**Quality Audit Response Document**  
**Proposed Mixed-Use Development**  
**Belgard Square East, Belgard Road**  
**and Blessington Road, Dublin 24**

## QUALITY AUDIT RESPONSE DOCUMENT

Quality Audit

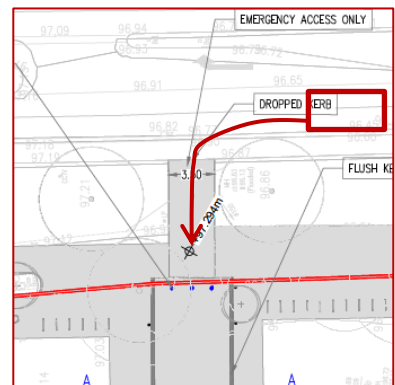
Two accesses have been indicated to the proposed development from Belgard Square East. The junction control (stop, yield etc.), and thus priority, at both of the development accesses has not been indicated. The absence of adequate road markings and signage, advising drivers of priority/control, may lead to driver confusion and hesitation resulting in drivers misinterpreting priority at the junction and entering the junction at the same time as opposing vehicles where there is an increased risk of side-on collisions.

Ensure the junction control, and priority, at the proposed development accesses is clear via signage and road markings.

'STOP' signs and road markings included to indicate priority at development access. Refer to drawing **Q003-CSC-ZZ-XX-DR-C-0022** for further details.

*Drawing:* Drawing no. Q003-CSC-ZZ-XX-DR-C-0006 (Rev. P3)

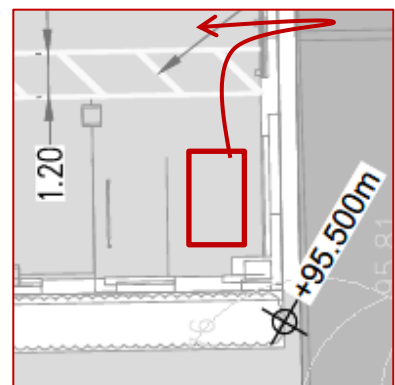
An Emergency Access has been indicated at the rear of the proposed development on Belgard Road, where a collapsible/demountable bollard will be located to deter unauthorised vehicular entry. Information regarding the swept path analysis of vehicles entering and exiting the development's emergency access has not been provided and it is therefore unclear if a fire tender or ambulance will be able to safely enter and exit the emergency access, and subsequently turn around when within the development.

Ensure that emergency vehicles can safely enter, turn, and exit the development.

A swept path analysis of emergency vehicles and fire tender has been undertaken to demonstrate that vehicles shall be able to access the development. Please refer to CS Consulting drawing no **Q003-CSC-ZZ-XX-DR-C-0009** for further details

*Location:* Drawing no. Q003-CSC-ZZ-XX-DR-C-0006 (Rev. P3)

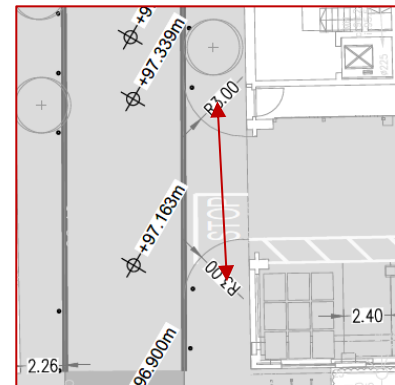
A swept path analysis should be undertaken within the internal carpark to ensure safe entry and exit to/from all spaces, and the layout revised if necessary.

A swept path analysis has been undertaken to ensure safe entry/exit of vehicles to/from all car parking spaces. Please refer to CS Consulting Drawing no. **Q003-CSC-ZZ-XX-C-0010** for further details.

*Drawing:* Drawing no. Q003-CSC-ZZ-XX-DR-C-0006 (Rev. P3)

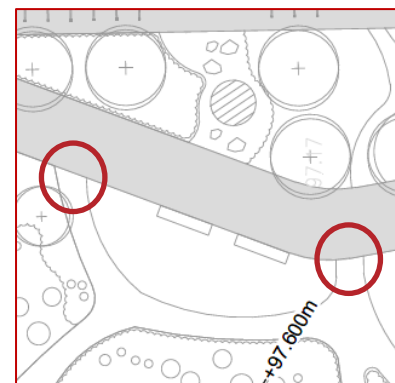
If the footway on either side of the carpark access is not flush with the access carriageway an uncontrolled pedestrian crossing, including dropped kerbs and tactile paving, should be provided.

Alternatively, if the footway is intended to be continuous across the access the access should be revised to make this clearer to both drivers and pedestrians.

The proposed access has been revised to clearly indicate the continuation of the pedestrian footpath across the proposed junction. The proposed 'STOP' marking have been removed. Please refer to CS Consulting drawing no. **Q003-CSC-ZZ-XX-DR-C-0022** for further details.

Drawing: Drawing no. Q003-CSC-ZZ-XX-DR-C-0021 (Rev. -)

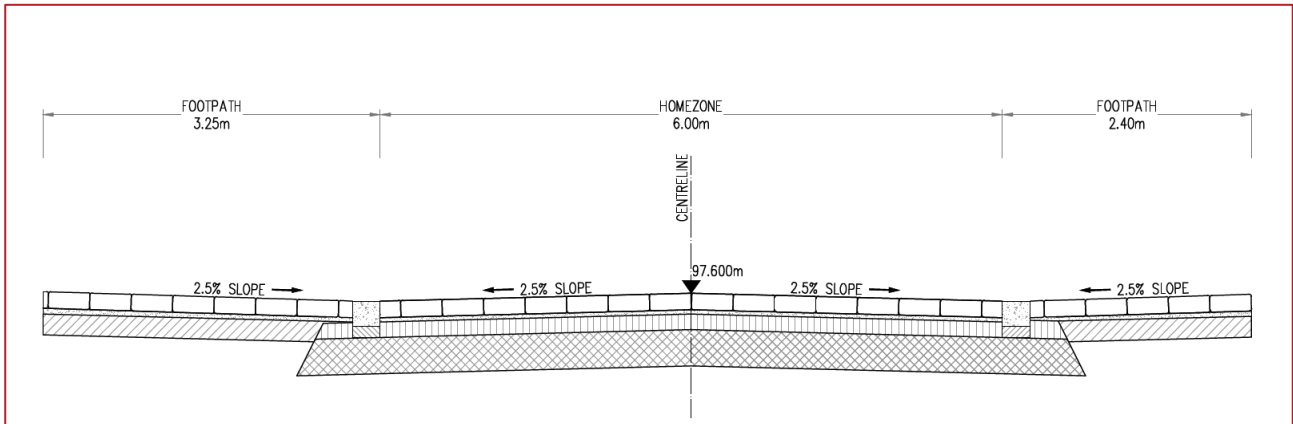
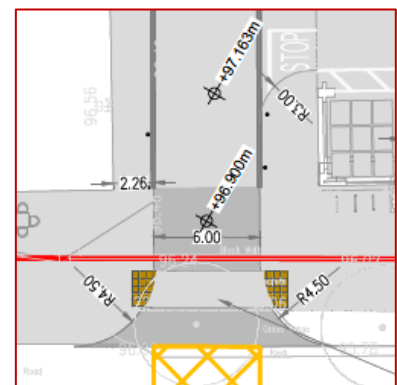
Summary: Visually impaired pedestrians may inadvertently enter the development's internal carriageway where they are at an increased risk of being struck by a vehicle.

The development's internal carriageway is indicated as being flush with the footway throughout the development, with both surfaces being delineated by a kerb strip only. Measures have not been indicated to advise visually impaired pedestrians of the potential hazard and this may therefore lead to them inadvertently entering the carriageway from the footway where they are at an increased risk of being struck by a vehicle.

A tactile strip should be provided within the footway adjacent the kerb strip throughout the development to advise visually impaired pedestrians of the carriageway hazard, and to define the 'safe zone' for them.

A tactile strip shall be provided adjacent to the proposed flush kerb to advise visually impaired users of the carriageway. Please refer to CS Consulting drawing no. **Q003-CSC-ZZ-XX-DR-C-0022** for details.

Drawing: Drawing no. Q003-CSC-ZZ-XX-DR-C-0006 (Rev. P3)

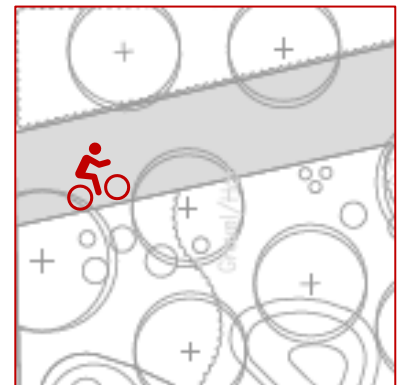
If a sufficient level difference between the footway and raised table is not provided, outside the extents of the tactile paving at the pedestrian crossing, a visually impaired pedestrian may be unable to detect the edge of the footway resulting in them inadvertently entering the carriageway where they are at an increased risk of being struck by a vehicle.

A level difference of 25mm minimum should be provided between the edge of the footway and the raised table at locations where tactile paving will not be provided such that the carriageway edge can be detected by a visually impaired pedestrian.

A tactile strip has been provided adjacent to where tactile paving is not being provided to advise visual impaired users of the carriageway hazard. This measure has been accepted by the audit team.

*Drawing:* Drawing no. Q003-CSC-ZZ-XX-DR-C-0006 (Rev. P3)

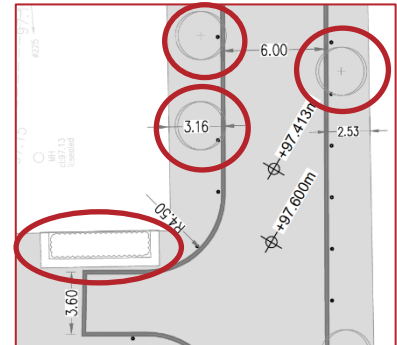
Information regarding the proposed drainage provision within the development has not been provided. Should insufficient drainage measures be provided, this could lead to ponding within the development's internal road or footway, particularly as these are at the same level, leading to loss of traction during wet or icy weather resulting in possible loss of control collisions or slips and falls for pedestrians.

Ensure the carriageway, and footways, within the development are sufficiently drained and that ponding does not occur.

A surface drainage drawing has been prepared for the proposed development. Please refer to CS Consulting Drawing no. **Q003-CSC-ZZ-XX-DR-C-0002** for further details.

*Drawing: Drawing no. Q003-CSC-ZZ-XX-DR-C-0006 (Rev. P3)*

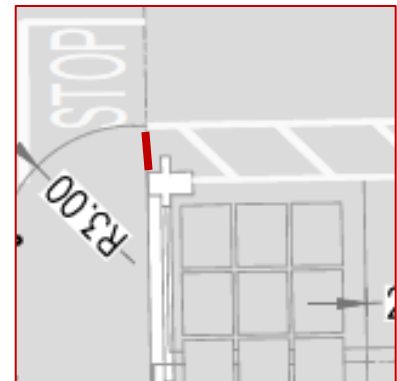
Items of street furniture, such as trees, bollards, and planters, have been indicated within the footway throughout the development and these may reduce the effective width of the footway. Should the effective width of the footways within the development be too narrow pedestrians, particularly wheelchair users, may be required to enter the carriageway to avoid obstacles, or opposing pedestrians, where there is an increased risk of being struck by a vehicle.

Ensure the footways within the development provide an unobstructed width of at least 1.2m minimum.

A minimum unobstructed width of 1.80m has been provided along footpath within the proposed development. Where trees are proposed there shall be slim-stemmed.

*Drawing: Drawing no. Q003-CSC-ZZ-XX-DR-C-0006 (Rev. P3)*

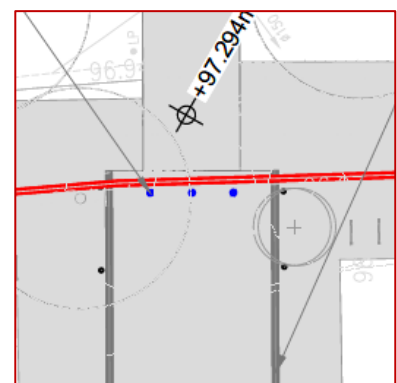
A small surface level carpark has been indicated within the proposed development. A dedicated pedestrian walkway has been indicated through the carpark transitioning to the footway at the carpark access. The carriageway and footway within the proposed development is indicated as being flush, however it is unclear if this also includes the carpark carriageway and adjacent footway. If the carpark carriageway, and subsequently the dedicated pedestrian walkway, is not flush with the adjacent footway pedestrians may be required to mount a full height kerb to access the footway from the carpark. This may lead to trips and falls for pedestrians resulting in personal injury collisions, or to mobility impaired pedestrians, particularly wheelchair users, having to continue within the carriageway to a suitable access location where there is an increased risk of being struck by a vehicle.

If the carpark carriageway and adjacent footway is not flush, a dropped kerb, and tactile paving, should be provided where the pedestrian walkway transitions to the footway.

Car park carriageway and adjacent footway shall be flush. This item has been accepted by the audit team. Refer to drawing **Q003-CSC-ZZ-XX-DR-C-0022** for further details.

*Drawing:* Drawing no. Q003-CSC-ZZ-XX-DR-C-0006 (Rev. P3)

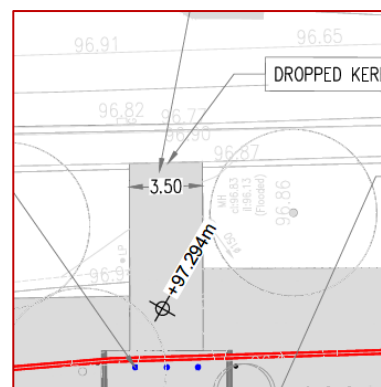
*Summary:* Risk of visually impaired pedestrians descending the dropped kerb at the emergency access and entering the Belgard Road carriageway, where there is an increased risk of being struck by a vehicle.

The upstand at the dropped kerb shall be 25mm. Refer to drawing **Q003-CSC-ZZ-XX-DR-C-0022** for further details.

*Drawing:* Drawing no. Q003-CSC-ZZ-XX-DR-C-0006 (Rev. P3)

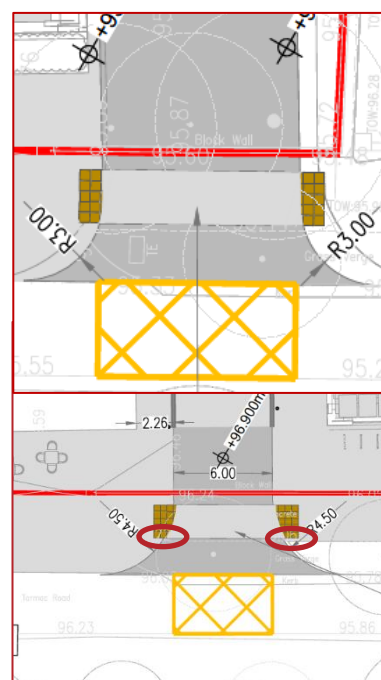
*Summary:* Tactile paving is not of the required depth.

Uncontrolled pedestrian crossings have been indicated across the accesses to the proposed development and basement carpark access ramp. The tactile paving on both sides of the crossing is not of the required depth for an inline crossing. Additionally, the tactile paving on both sides of the northernmost development access is not of the required depth for an inline crossing across the full width of the crossing.

Tactile paving of minimum depth 1.2m shall be provided across the full width of crossing. Please refer to CS Consulting drawing no. **Q003-CSC-ZZ-XX-DR-C-0022** for details.

*Drawing: Drawing no. Q003-CSC-ZZ-XX-DR-C-0006 (Rev. P3)*

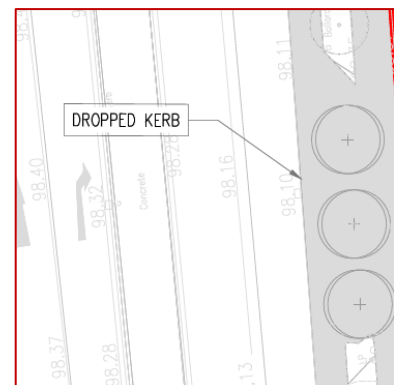
The gradient of the access ramp to the basement carpark has not been indicated and it is therefore unclear if it will be sufficient for drivers and cyclists to traverse safely. If the gradient of the ramp is steeper than 1:20 there is a risk that cyclists may experience discomfort when using the ramp leading to loss of control type collisions. A steep gradient may also lead to high speeds as vehicles and cyclists descend the ramp and enter the carpark resulting in the potential for loss of control type incidents and collisions with opposing, or parked, vehicles.

Ensure the gradient of the ramp to the basement carpark is sufficient to permit the safe access and egress for drivers and cyclists.

The proposed access ramp shall have a maximum gradient of 1:15. The proposed ramp is for vehicle use only.

*Drawing: Drawing no. Q003-CSC-ZZ-XX-DR-C-0006 (Rev. P3)*

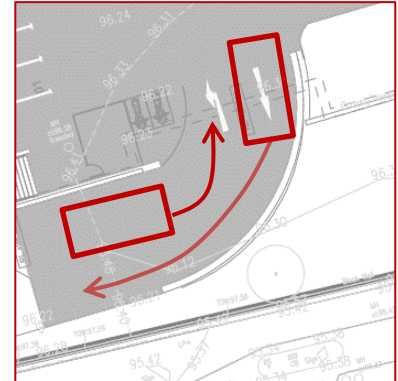
If vehicular access is not required from this location, the dropped kerb should be replaced with a full height kerb.

Alternatively, if necessary to retain the dropped kerb, ensure it has a minimum upstand of 25mm.

Proposed dropped kerb shall have a minimum upstand of 25mm.

*Drawing:* Drawing no. Q003-CSC-ZZ-XXDR-C-0008 (Rev. P1)

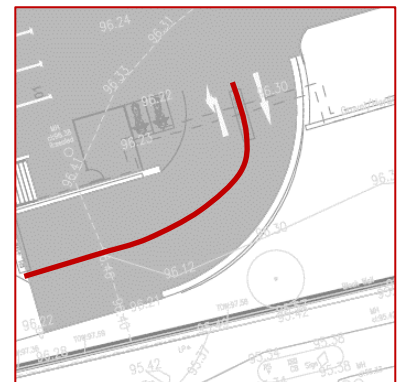
The basement carpark access ramp includes a tight horizontal radius, and it is unclear if two opposing vehicles can pass each other safely on the ramp, particularly when entering/exiting at the bottom of the ramp. If sufficient space is not available on the ramp for two opposing vehicles to pass there is an increased risk of side swipe collisions.

Confirm, via swept path analysis, that opposing vehicles can safely traverse the basement carpark access ramp. If necessary, revise the layout of the ramp to accommodate two-way traffic.

A swept path analysis has been undertaken to demonstrate that opposing vehicles can transverse the basement access ramp. Please refer to CS Consulting Drawing no. **Q003-CSC-ZZ-XX-DR-C-0011** for further details.
